Mayor Meeting

Public Meeting Agenda

28980 – Richard Beckstrand is requesting preliminary plat approval of a 2 lot subdivision. The applicant is proposing to divide the existing property at the subject location to create an additional lot. **Location:** 3809 East Thousand Oaks Circle **Zone:** R-1-10 (Single Family Residential) **Planner:** Spencer W. Brimley

STAFF REPORT

Exhibit "E": 2 Assessor Pictometry Aerials

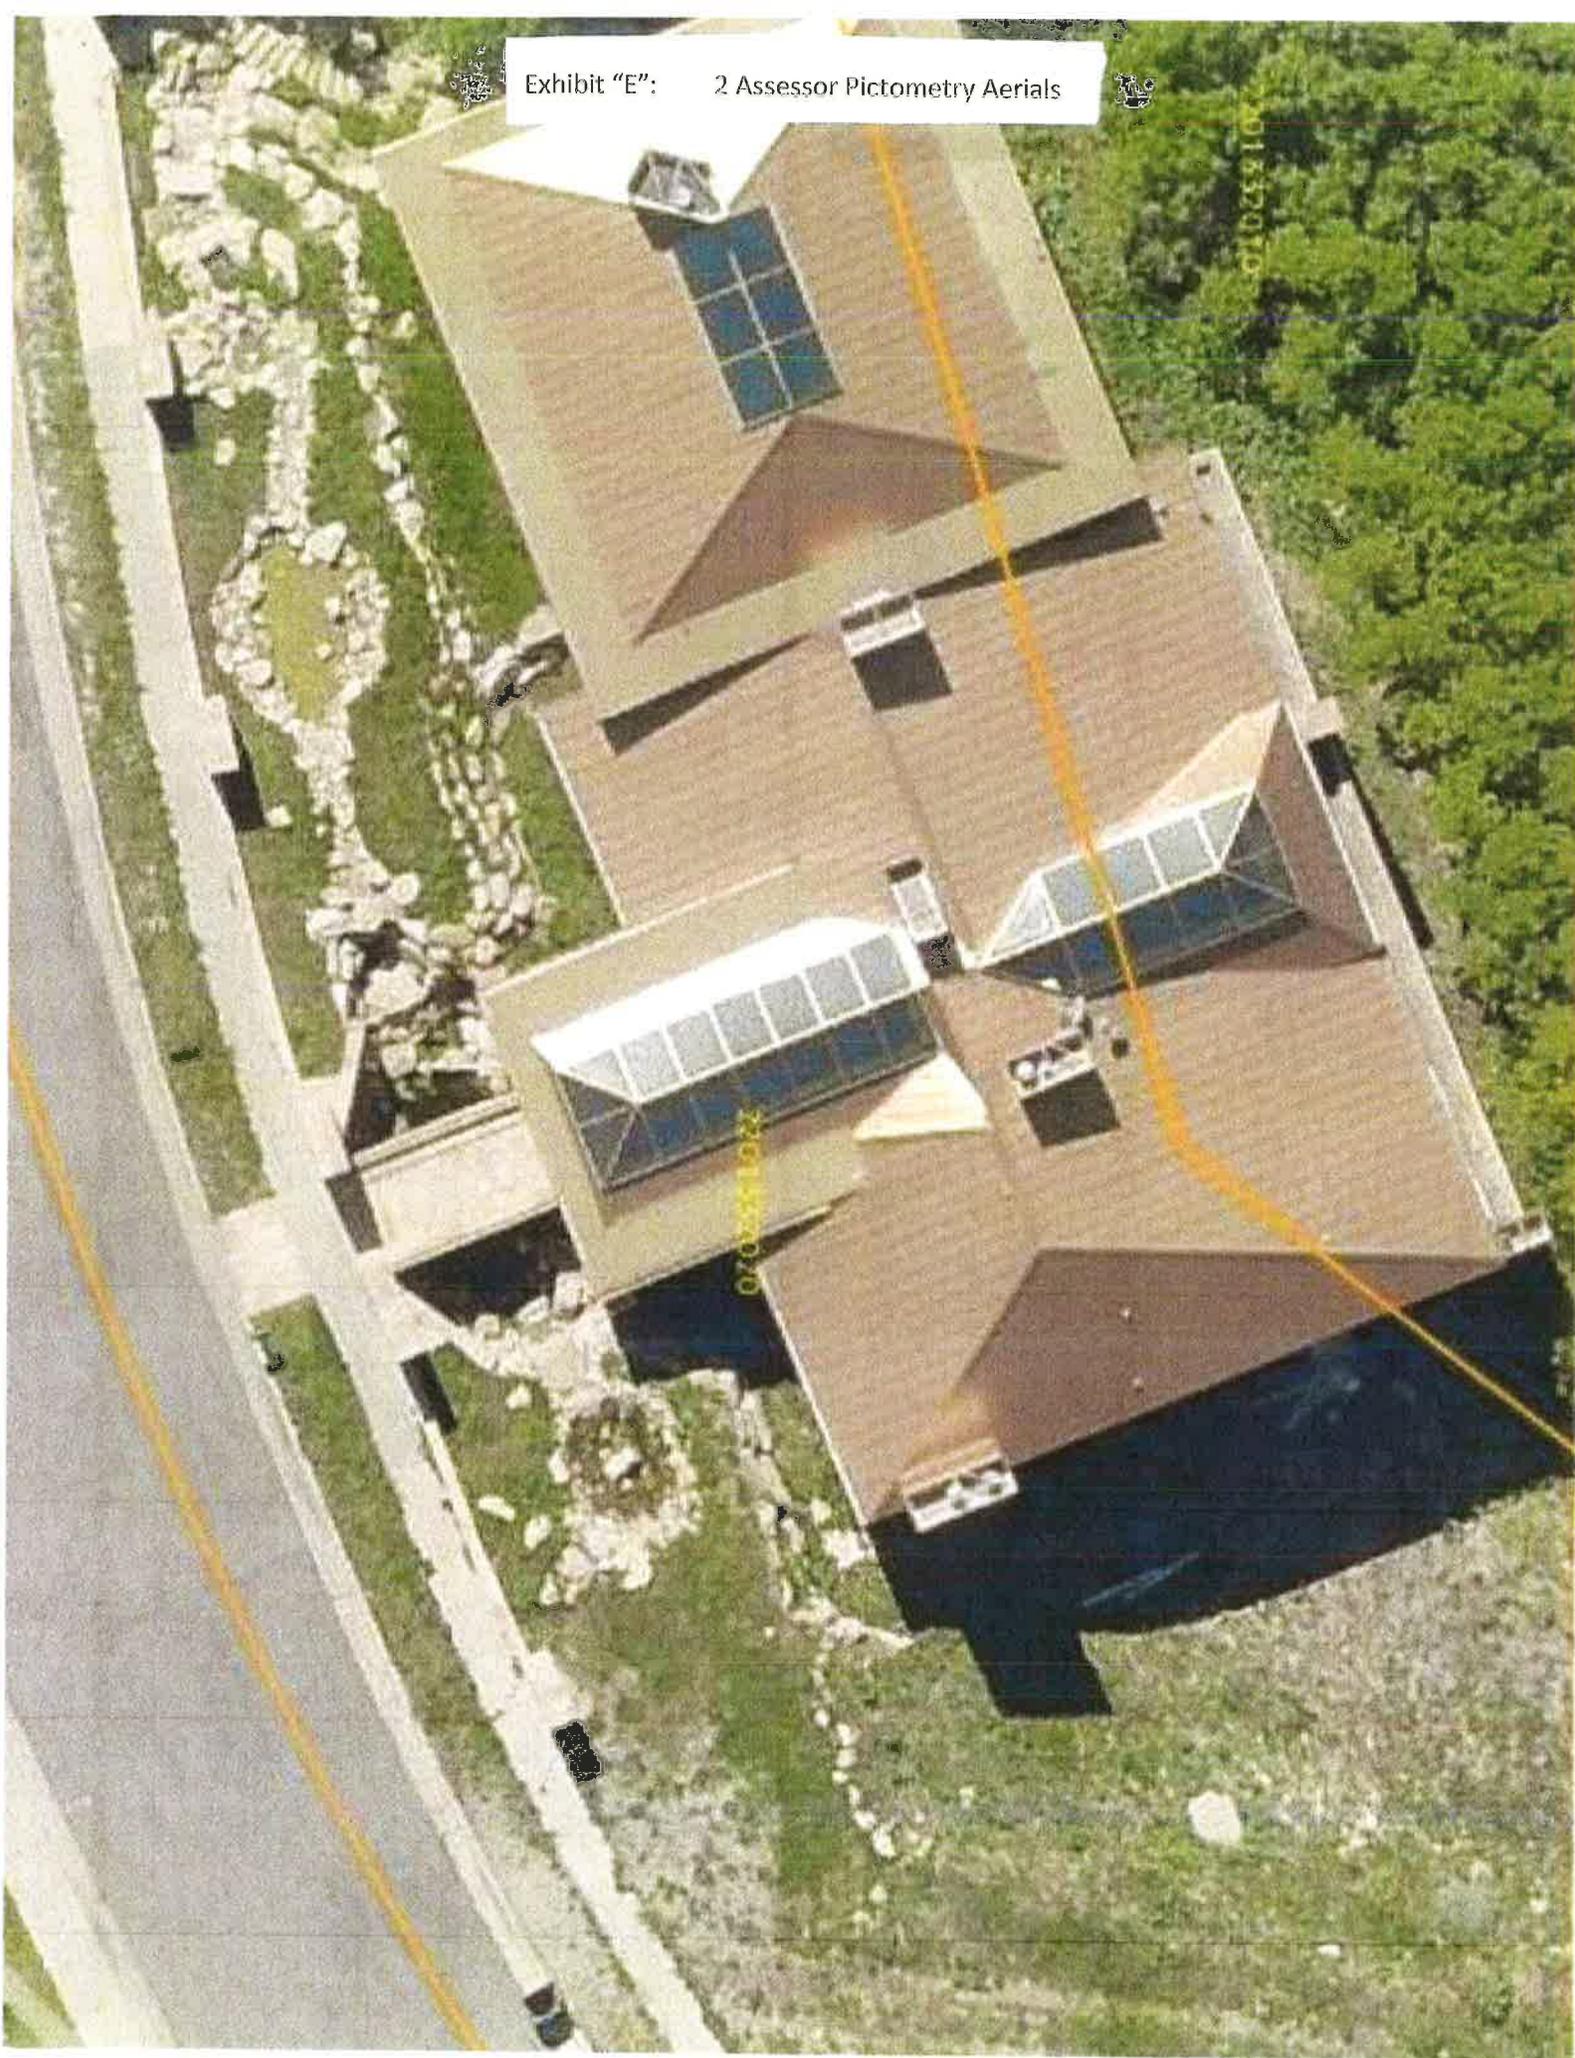
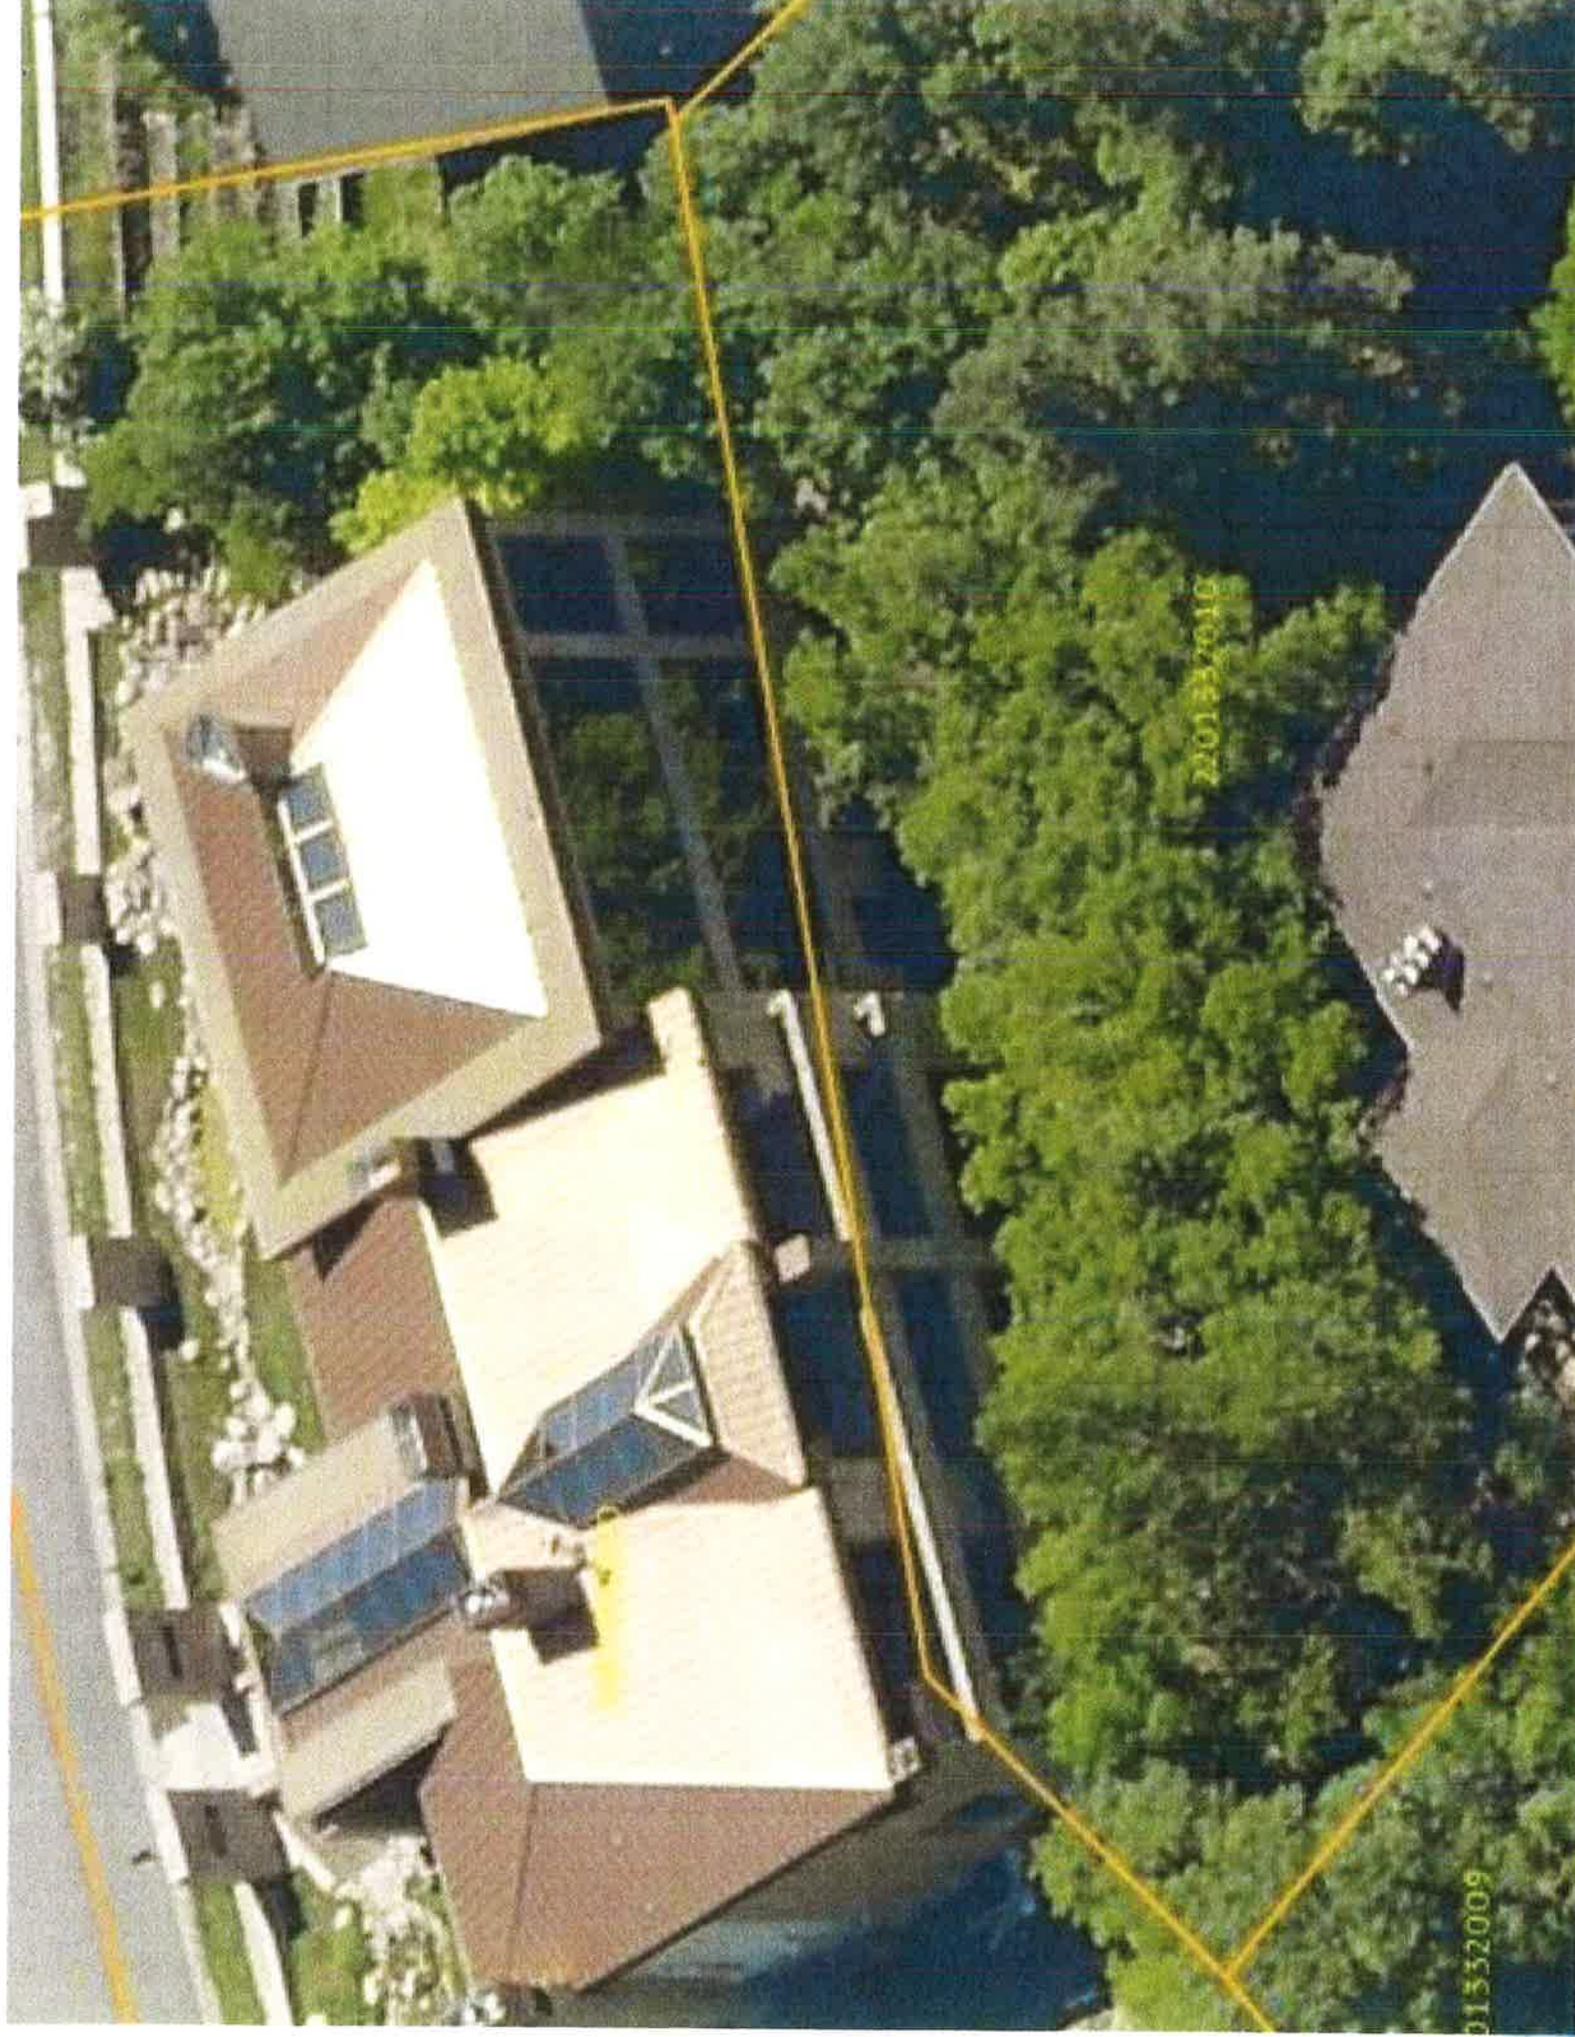
- Takeoff measurements at Assessor's office with Alan Muhlestein
- Suggest Roof Perimeter of 6,269 SF (Exceeds Maximum Allowable Building SF)
- Exhibit "E" (2 Assessor Pictometry Aerials)

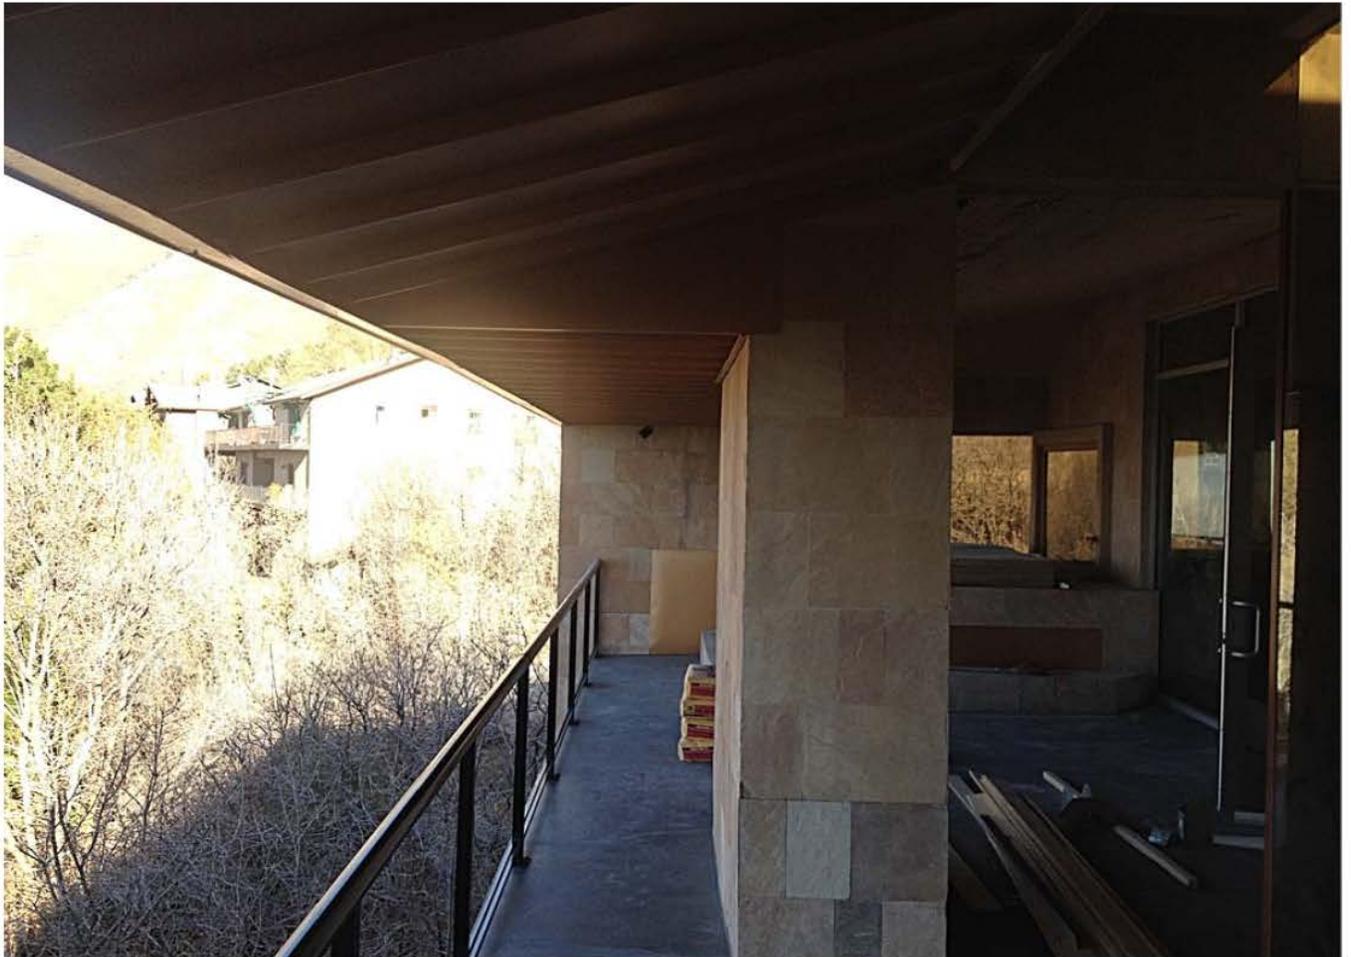
This addendum to the original correspondence dated 9/30/14 updates the neighborhood opposition to the above noted applications. After further discussions with Salt Lake County planning staff, we have recalculated the lot coverage ratios and the side yard setback requirements. We now believe the applicant's side yard setbacks approximate the requirements of the RCOZ. However, and of paramount concern, the proposed lot coverage ratios will clearly not conform to the maximum percentages allowed by the ordinance.

The applicant has not requested any exception to the mandatory lot coverage ratio stipulated within Table 1 of the RCOZ ordinance. The RCOZ ordinance allows up to 31% lot coverage for the main dwelling. Please note there are multiple sources of square footage estimates of the current main residential footprint which directly affect the lot coverage calculations once the garage is to be built. Specifically, the applicant calculates the main structure square footage to be 4,720 square feet. The Salt Lake County Assessor calculates the footprint to be 4,816 square feet plus an additional 333 square feet for the covered front porch in front and 2,463 square feet for the covered porches on the rear of the home. Multiple previous private party representations in the Wasatch Front Multiple Listing Service have portrayed the footprint to be 5,186 square feet without inclusion of deck space. **We respectfully request that the applicant be required to provide a certified professional survey of the current footprint containing all pertinent data supporting applicant's calculations to validate his smaller and highly beneficial square footage.** It appears the applicant may not have accounted for the covered deck space contained within the present improvements and must adjust the proposed square footage/acreage of the proposed lot 1517A to achieve the mandatory 31% maximum lot coverage. The neighborhood independently estimates the square footage and lot coverage calculations contained in the table below, along with the remaining acreage available for the proposed Lot 1517B after the current and/or proposed improvements on Lot 1517A achieve compliance.

The applicant has failed to address both the current and the proposed lot coverage violations and has failed to satisfy the associated burden of proof required to secure any extraordinary exceptions. In fact, according to the formal application, the applicant did not provide any justification whatsoever and did not draw the Salt Lake County planning staff's, Olympus Cove Community Council's or the Millcreek Township Planning Commission's attention to this discrepancy. **As proposed, the application is non-compliant on maximum lot coverage and does not meet the requirements for approval.**
